PCN #: 20070518001
Texas Instruments Incorporated
Enterprise Notification

**Addition of RoHS Designation
Symbols to Semiconductor
Product Labels**

Release Date: July 21, 2007

Example: Non-RoHS Compliant Products (RoHS compliant except for Pb, no exemption)

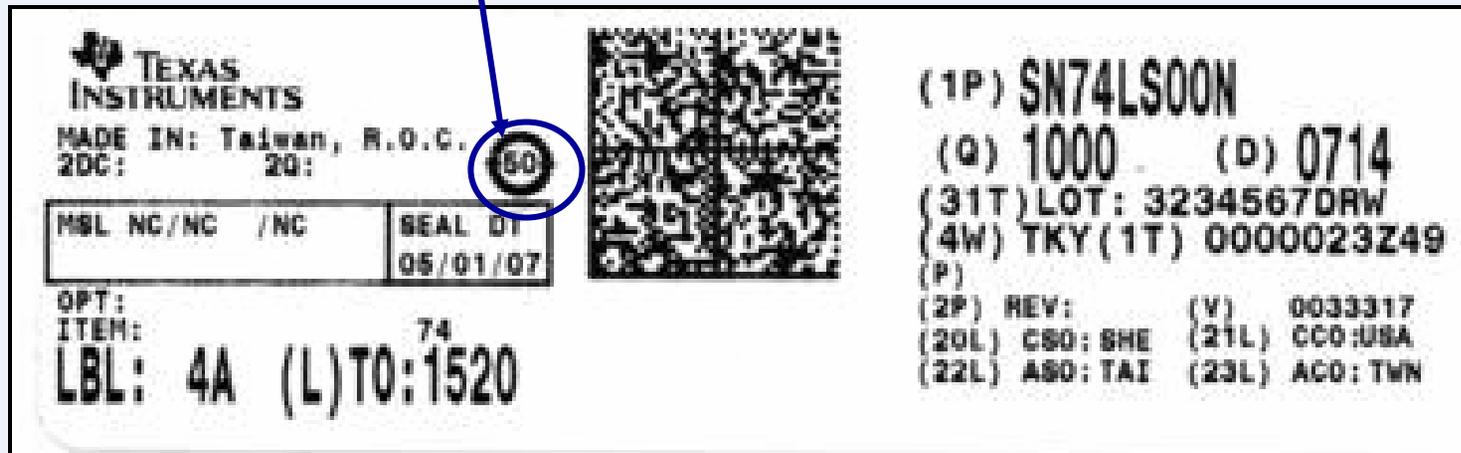
- New ECAT Symbol: per proposed J-STD-609 format
